Date: August, 2021

Design Change of Display Mounting Systems

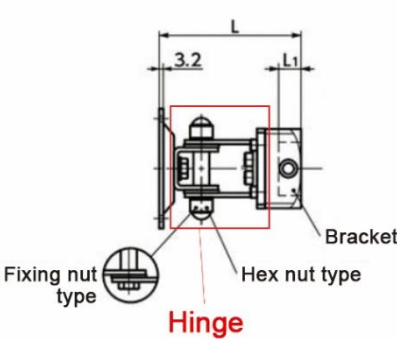
The common hinge in the pertinent products will be changed to the specifications below (image is DFSN-AA).

Changes	Before Change	After Change

The dimensions and performance on the product pages will remain the same.
